**STAFF RECOMMENDATION**  
**1903 Holly Street**  
**May 19, 2021**

**Application:** New Construction—Infill  
**District:** Lockeland Springs-East End Neighborhood Conservation Zoning Overlay  
**Council District:** 06  
**Base Zoning:** R6  
**Map and Parcel Number:** 08314001800  
**Applicant:** Craig Kennedy, Architect  
**Project Lead:** Sean Alexander, sean.alexander@nashville.gov

SITE PLAN

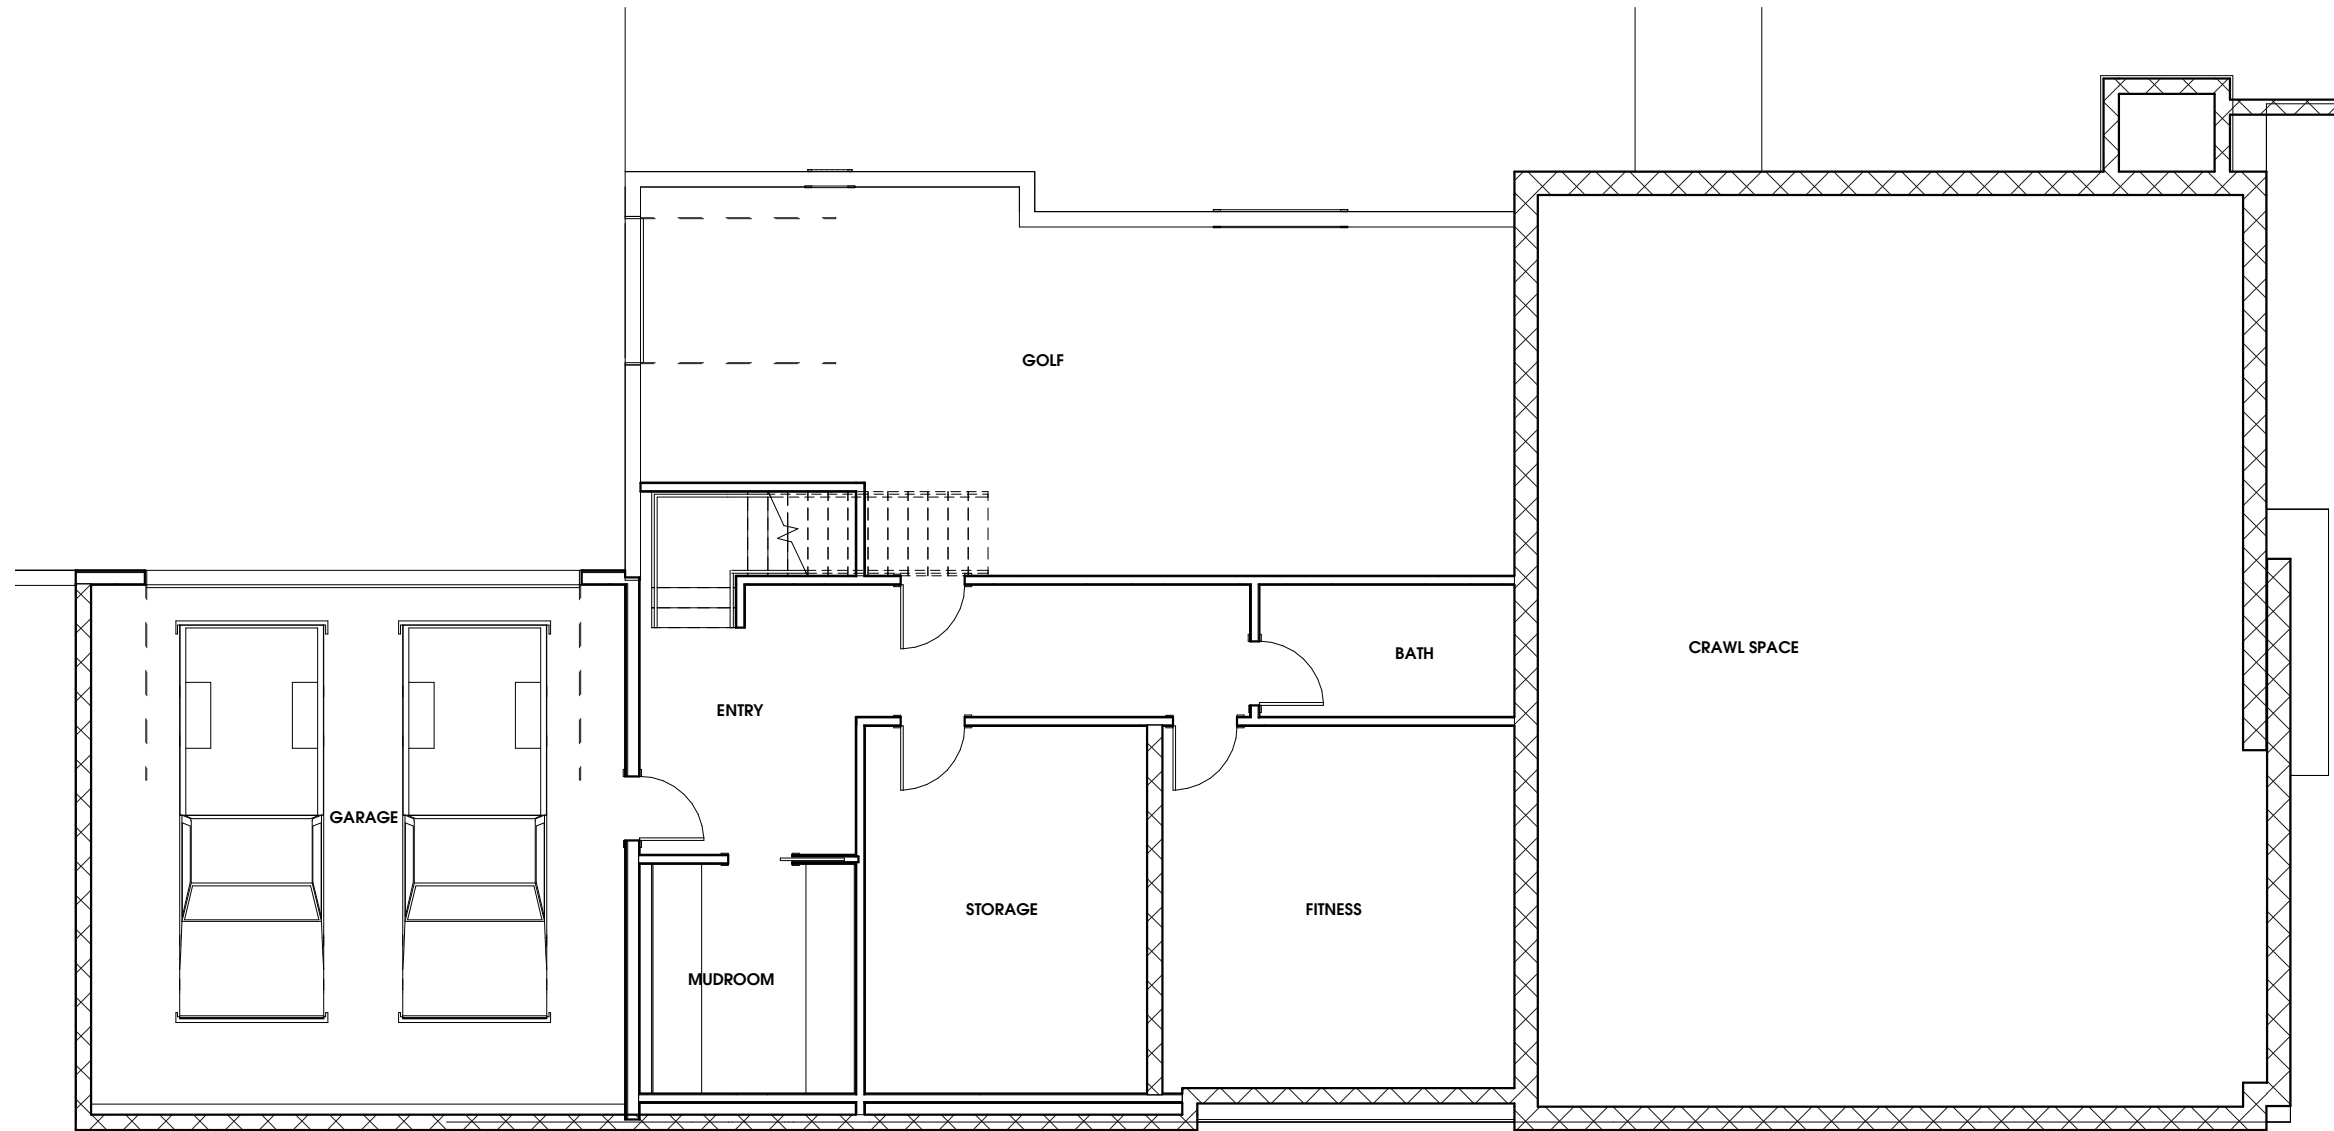
Setback & Rhythm of Spacing: The front edge of the building is proposed to be thirty-six feet (36') from the front of the property. The two adjacent houses, which are both infill replacing houses destroyed by the tornado, were approved with setbacks of thirty-three feet (33') and thirty-four feet (34'). Staff recommends that this new house should have a front setback that is halfway between that of the two adjacent houses, to be verified with a staking inspection at the start of construction.

The building's side setbacks will be six feet (6') on the left side and fourteen feet (14') on the right. The separation between the proposed new building and the house to the right will be thirty-six feet (36'), because both houses will have driveways along the shared property line. The two houses on these lots previously had driveways in the same locations. Staff finds that the side setbacks are consistent with the rhythm of spacing in the historic context.

Appurtenances & Utilities: A new walkway in the front yard will connect from the front porch to the front of the lot, and a driveway will be constructed on the right side of the house to access a garage in the basement. These features will replace an earlier front walkway and driveway, in the same locations as with the previous house. These features are compatible with the surrounding area as there is no alley at the rear of this block. The location of the HVAC units are shown on the left side of the house, beyond the midpoint.

With a condition that the new house at 1903 Holly Street has a front setback halfway between that of the two adjacent houses, to be verified with a staking inspection at the start of construction, Staff finds that the front and side setbacks will meet section II.B.3 of the design guidelines.

1 HOLLY STREET ELEVATION

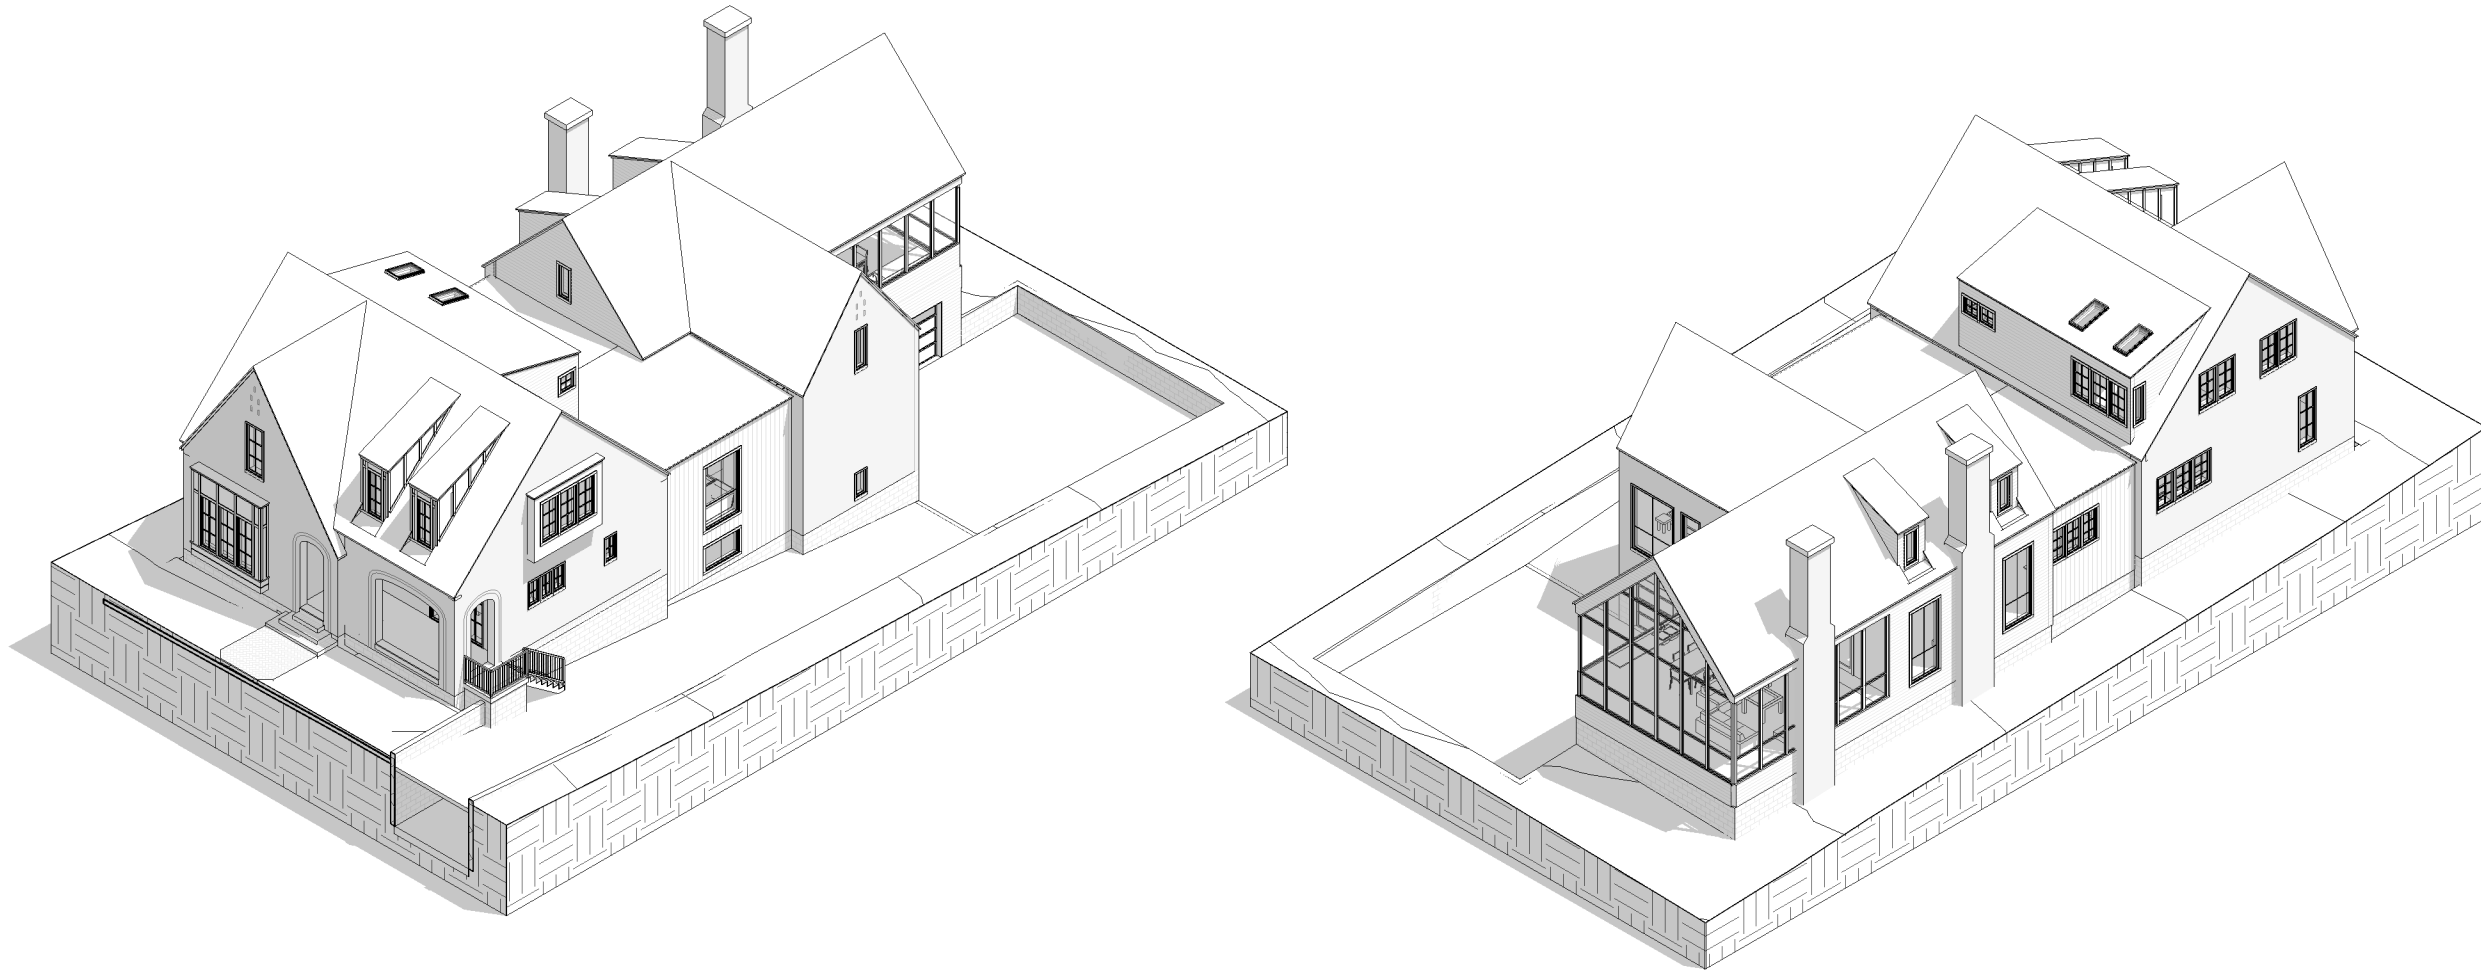
**Height & Scale:** The new house will be one-and-one-half-stories at the front, with a roof-ridge height of twenty-nine feet, nine inches (29' 9") from grade, including a foundation height of two feet (2') at the front. The eave height will be thirteen feet, ten inches (13'-10") from grade. The historic context on this block is composed of one-story houses ranging from thirteen feet (13') to twenty-four feet (24') tall, and one and one-half-story houses ranging from twenty-five feet (25') tall to thirty-five feet (35') tall.

The lot currently slopes down from the street to the rear, so the applicant is proposing to add fill to the front yard to direct water away from the house. Staff finds that increasing the height of the foundation and raising the grade is appropriate, in this case as it will be compatible with adjacent structures, but requests to verify that the floor level is consistent with the surrounding context with an inspection before the floor system is installed.

With a condition that the foundation height is compatible with the historic houses on the block, to be verified with an inspection during construction, staff finds that the height, width, and massing of the proposed new building is appropriate and the proposal meets sections II.B.1 and II.B.2 of the design guidelines.
